FILE NO.: Z-10117

NAME: The Oyster Bar Employees Parking – PD-C

LOCATION: 109 S. Booker Street

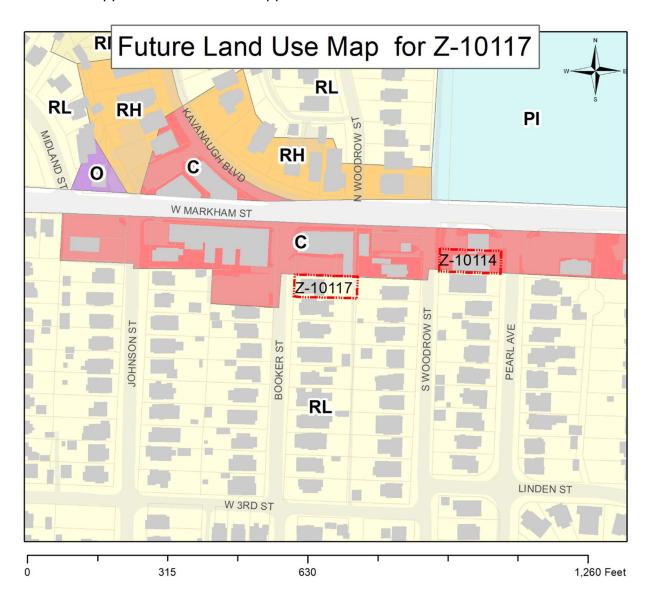
- 1. The retaining wall along the front side of parking is severely damaged and shall be proposed to be replaced before staff would allow parking to be adjacent to it.
- 2. The proposed parking lot must contain one (1) handicap van accessible stall/aisle.

- 1. Due to the proposed use of the property, the Master Street Plan specifies that Booker Street for the frontage of this property must meet commercial street standards. Dedicate right-of-way to 30 feet from centerline.
- 2. Per the Off-Street parking design standards for 60 degree parking, at minimum of 36 ft in width is required.
- Repair or replace any curb, gutter, sidewalk and access ramps that are damaged and not in compliance with ADA recommendations in the public rightof-way prior to occupancy.
- 4. The proposed parking lot is one (1) property south of public street project Job 061839, Pearl Ave to S. Martin St. Improvements (Markham St. Lane Reduction) proposed to go to construction in the future. The subject property does not appear beyond the limits of the public project. The proposed plan should be reviewed by the applicant.

The proposed parking lot contains an existing metal guard rail and stone wall along the north property line. The applicant proposes to build a six (6) foot tall, wood privacy, fence and typical landscaping along the south property line.
